*Appendix E to Consent Decree*

*Annex 2 to  
Statement of Work  
for Removal Actions  
Outside the River*

*Documentation Related to  
Source Control Activities  
(Continued)*

Pittsfield/Housatonic River Site  
General Electric Company  
Pittsfield, Massachusetts

7

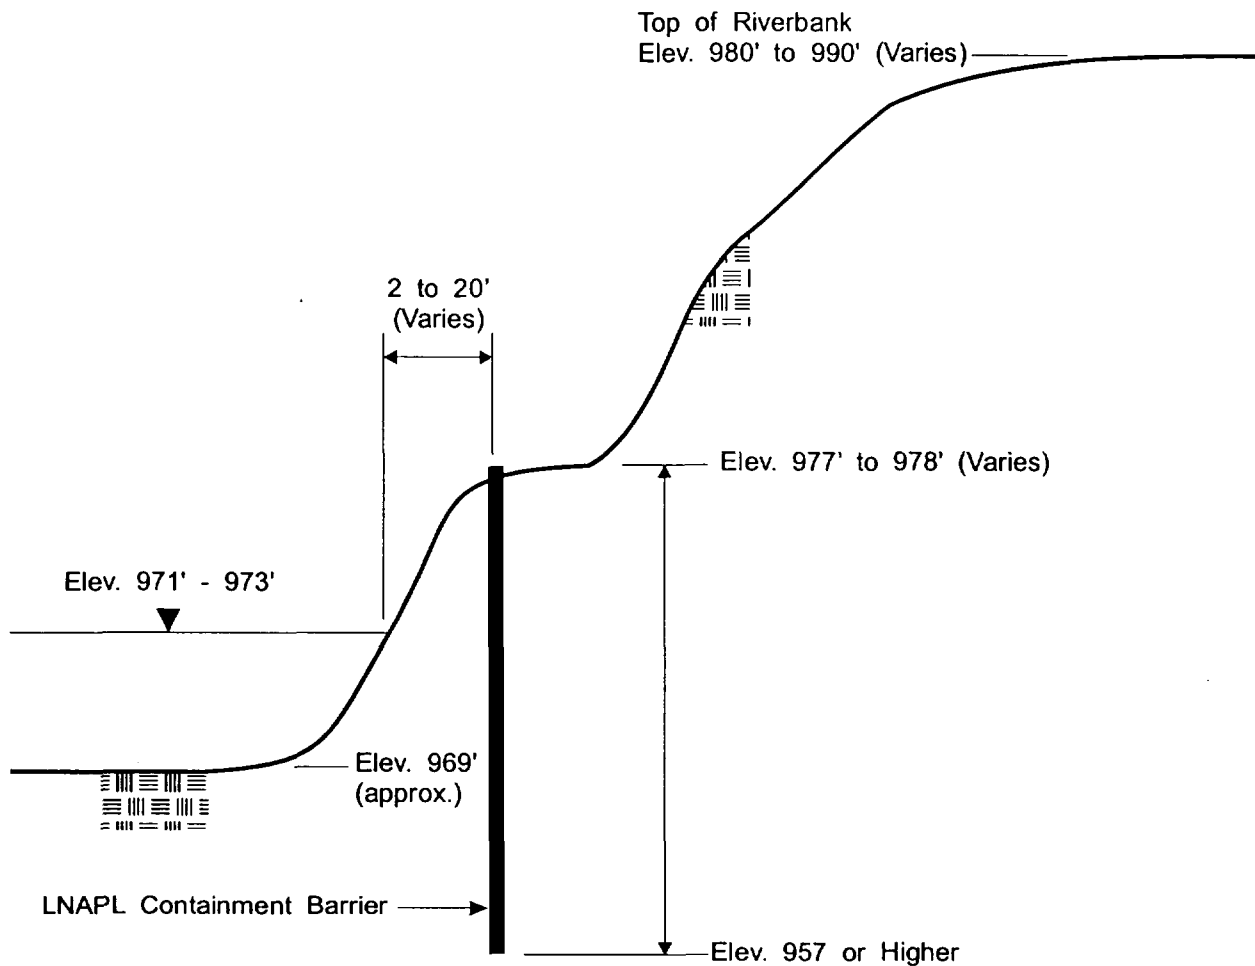
8. GE shall add two additional sample locations, one between P-2 and P-4 and one approximately 30 feet east of P-5. Also, GE shall relocate two of the samples as shown on a revised Figure 7 (see attached).

FIGURE **4**

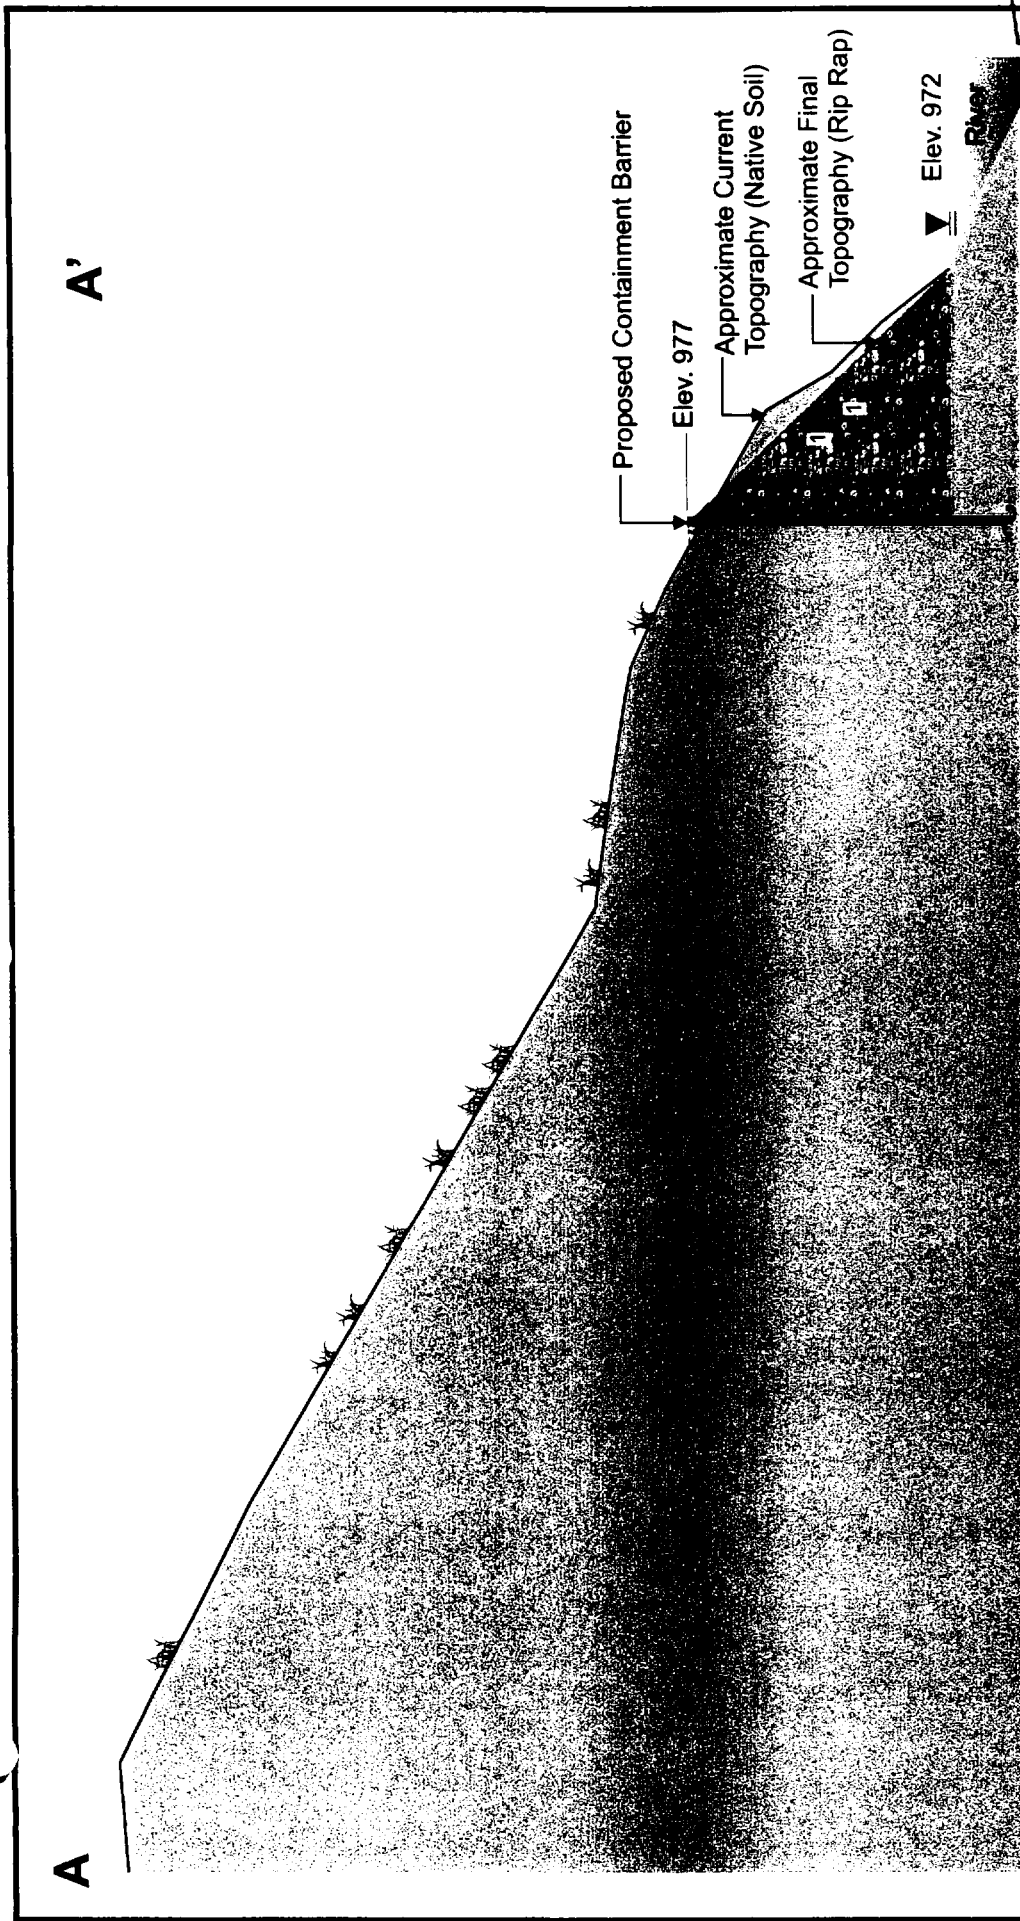
### **Page 6, 3rd paragraph and Figure 4. Containment Barrier Profile (and/or other contract drawings/specifications)**

Include the following as notes on Figure 4 and other appropriate contract drawings/specifications:

***Revised Sheet 4 of Appendix D of the  
Supplemental Source Control Proposal***

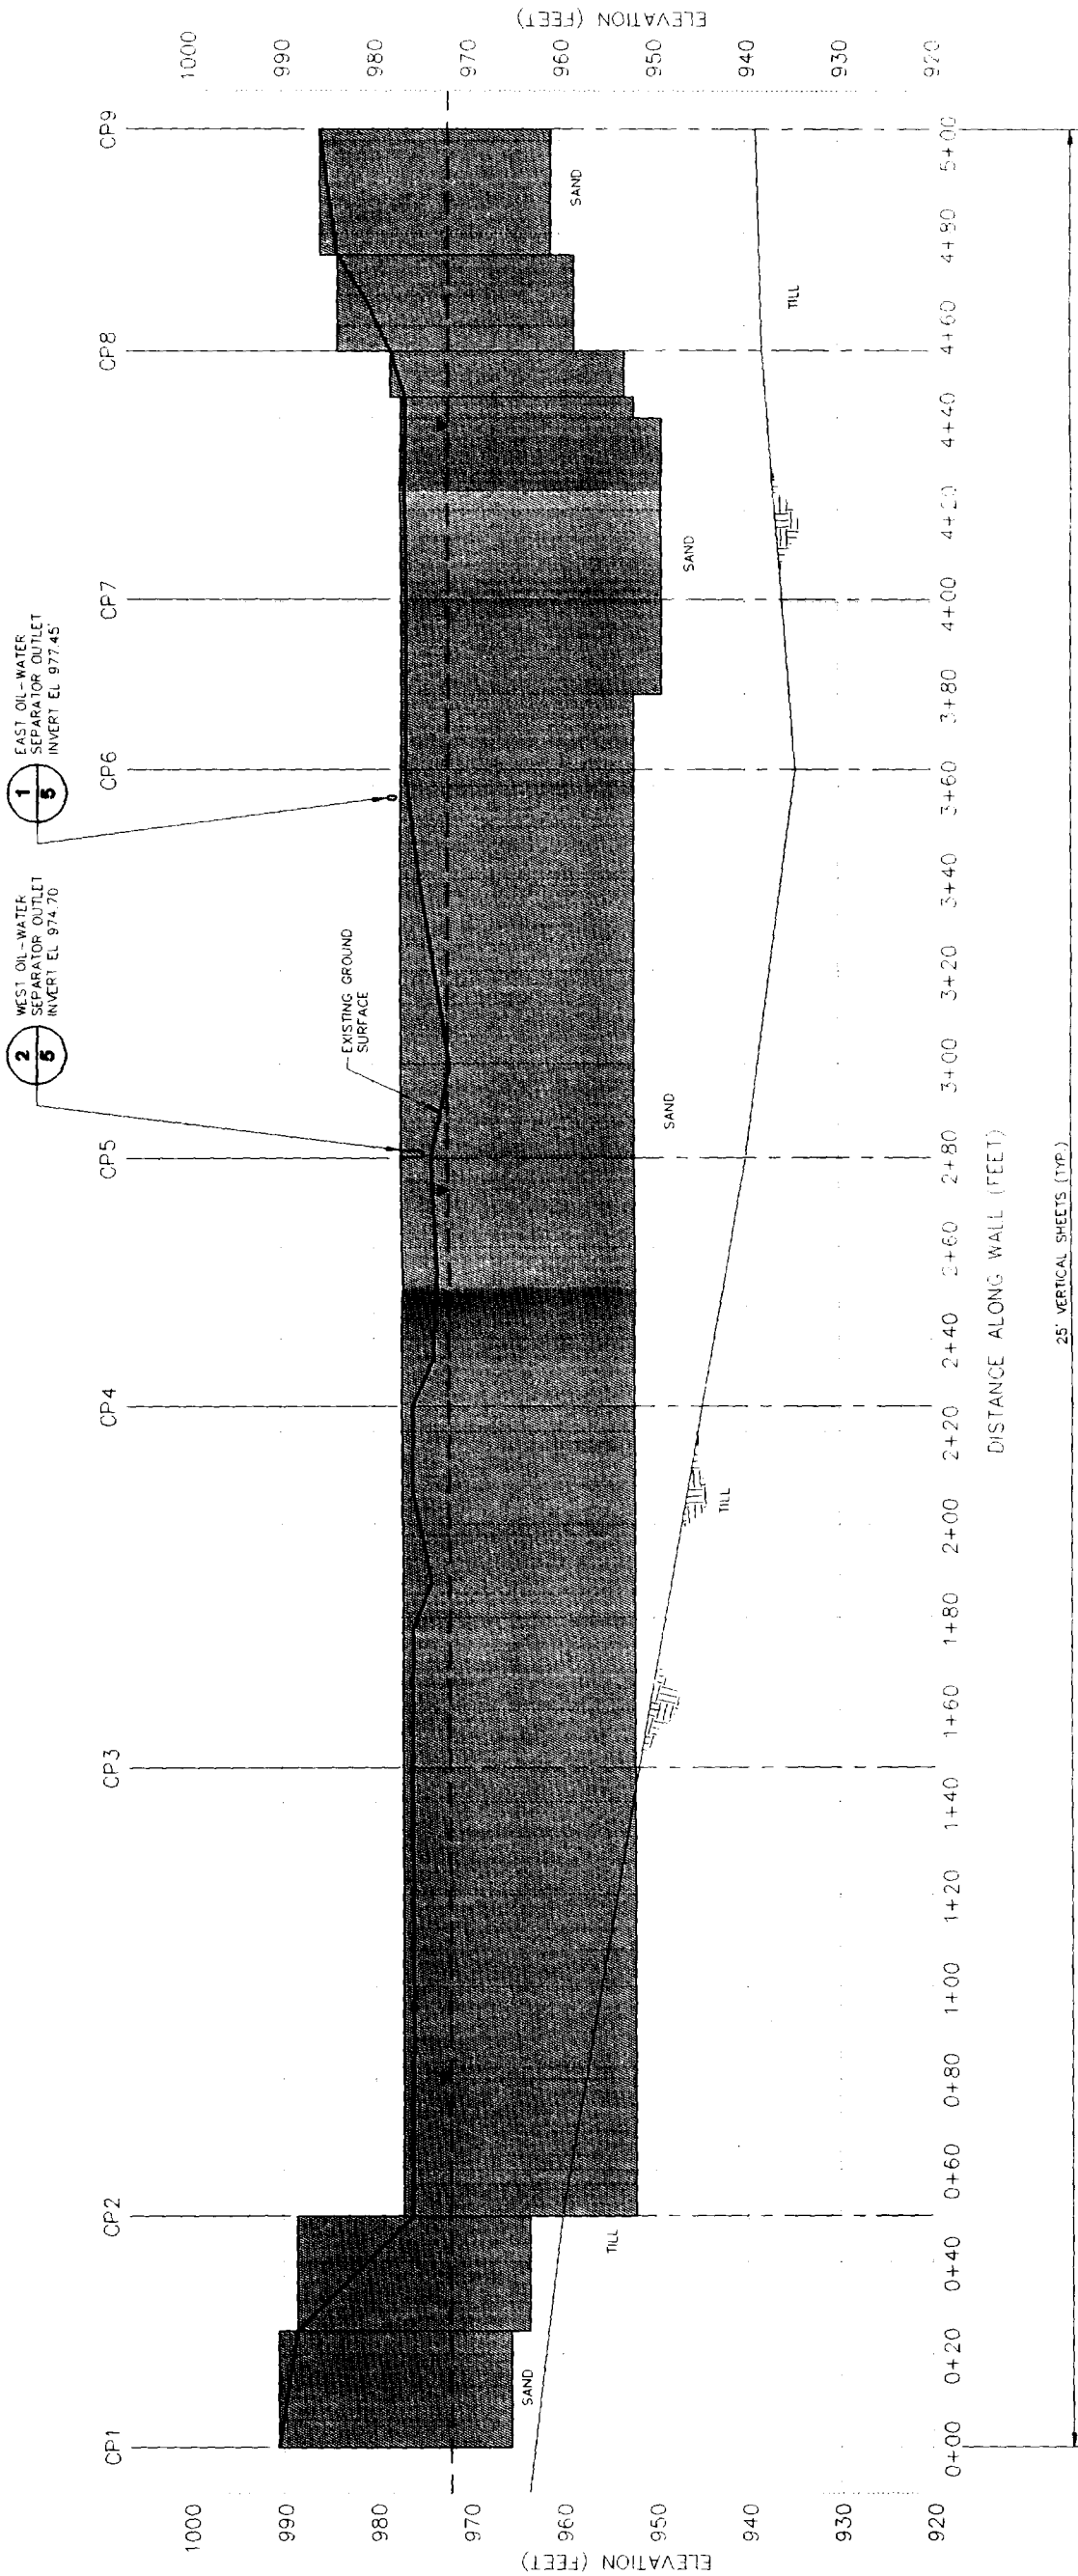
- 1) USEPA requested consideration by GE of the installation of a "heavy-duty woven geotextile or geogrid" beneath the proposed riprap.
- 2) USEPA requested the addition of two notes on Sheet 4 in Appendix D (summarized as):

- 2) GE will incorporate notes to Sheet 4 similar to those suggested by USEPA. A revised Sheet 4 is presented in Attachment 2.

***Revised Sheet 5 of the Supplemental  
Source Control Proposal***

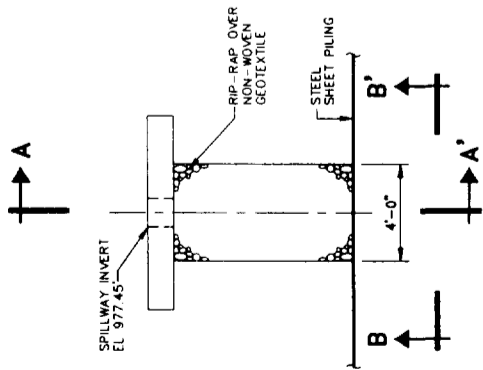
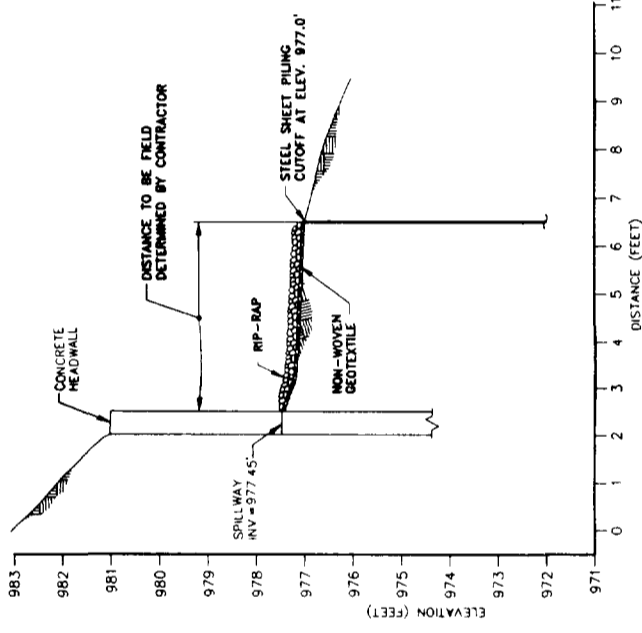
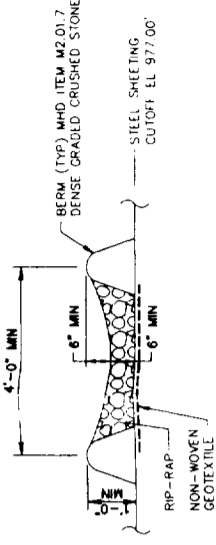
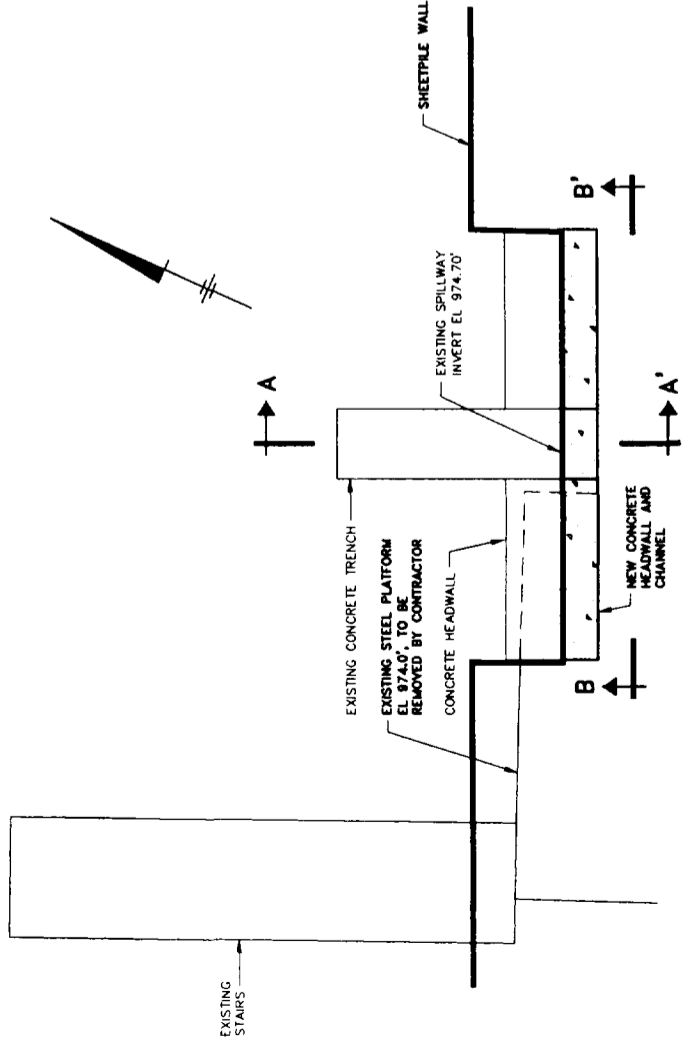
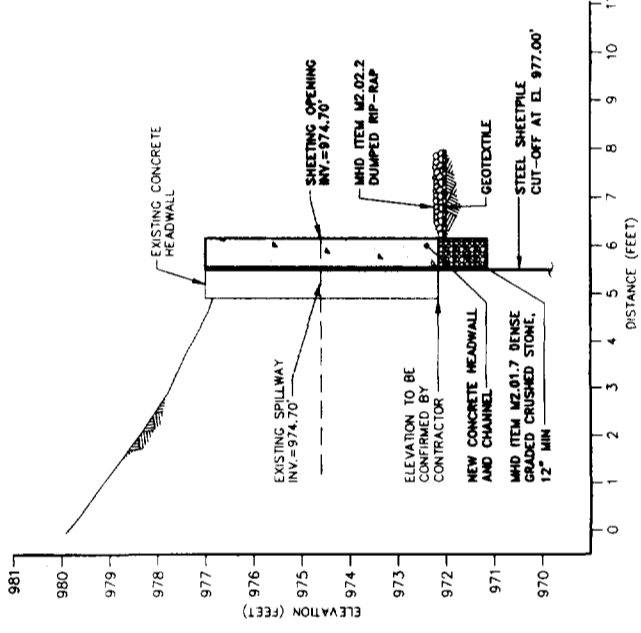
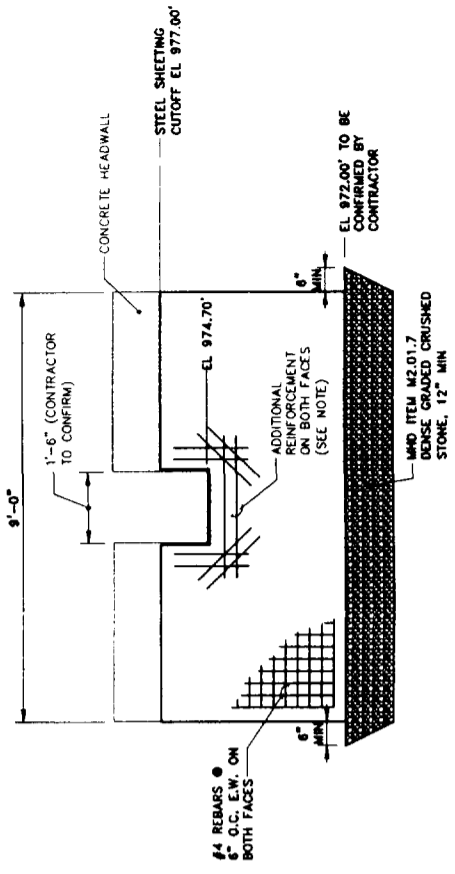
As part of its February 11, 1999 conditional approval letter, the USEPA presented several comments concerning the proposed configuration of the sheetpile wall in the vicinity of the west headwall as presented on Sheet 5 of Appendix D of the Supplemental Source Control Proposal. In general, these comments relate to the integration of the sheetpile wall with the headwall without resulting in permanently exposed sheetpiles along this portion of the river.

In response to these comments, the alignment of the sheetpile wall in the vicinity of the west headwall has been modified to address the USEPA's comments. The modified connection details are shown on Figure 1 and in Attachment 4. Specifically, the sheetpile wall alignment has been changed such that it will extend out flush with the front face of the west headwall, with the use of "L" sections on either side of the headwall. To accomplish this, longer sheets will be used in this area so that the driving hammer will not be obstructed by the existing headwall. The sheets will then be cut flush with the top of the headwall once they have been driven to the desired depth. A new concrete headwall will be constructed on the face of the sheetpile such that the sheetpile will not be exposed. Geotextile and riprap will be placed at the excavated toe of the bank slope as a measure of erosion protection until such time that final excavation and restoration activities are conducted as part of the ½-Mile Removal Action Work Plan activities.
